Work Order ID 103308

Item Name: Lug

DRAWING NO. D3394		TITLE LUG		REV. B	DART AEROSPACE LTD ENGINEERING ORDER		D.E.O. NO. D3394-B-1		SHEET NO. SHEET 1 OF 1		SCALE NTS	
DRAWN AJS		CHECKED		MFG. APPR.		APPROVED		DE APPR.				
DATE 09.11.04		DATE 09/11/04		DATE 09-11-04		DATE 09/11/04		DATE 09/11/04

DRAWING NO. D3394	TITLE LUG	REV. B	DART AEROSPACE USA, INC ENGINEERING ORDER		D.E.O. NO. D3394-B-2	SHEET NO. SHEET 1 OF 1	SCALE NTS
DRAWN <i>qp</i>	CHECKED <i>Sc</i>	MFG. APPR. <i>M</i>	APPROVED <i>JP</i>		DE APPR. <i>H</i>		
DATE 11.05.02	DATE 11.05.09	DATE 11.05.09	DATE 11.05.09		DATE 11.05.09

SECTION A-A

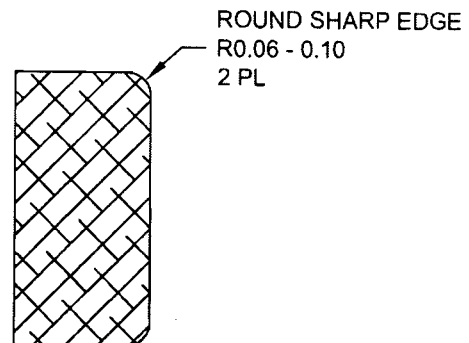
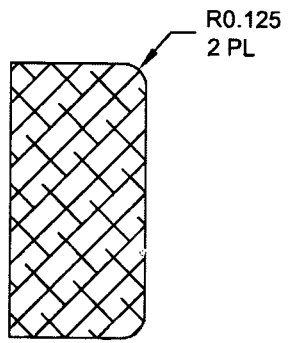
SHEET 4 ZONE A,1 MODIFY SECTION A-A AS SHOWN:

REASON: DRAFTING ERROR

D3394-1RG LUG (SHOWN)
D3394-3RG/-5RG LUGS (SIMILAR)
D3394-041RG/-043RG/-045RG LUG ASSEMBLIES (SIMILAR)

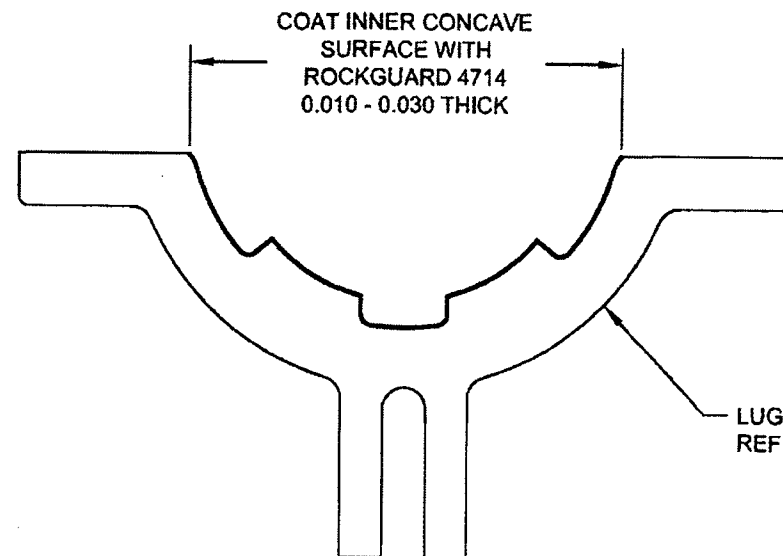
ADD D3394-xRG OPTION

D3394-xRG MOUNTING LUGS ARE IDENTICAL TO D3394-x MOUNTING LUGS, HOWEVER AFTER FINISH, COAT INNER CONCAVE SURFACE WITH "PLUS ONE ROCKGUARD 4714" AS SHOWN BELOW.
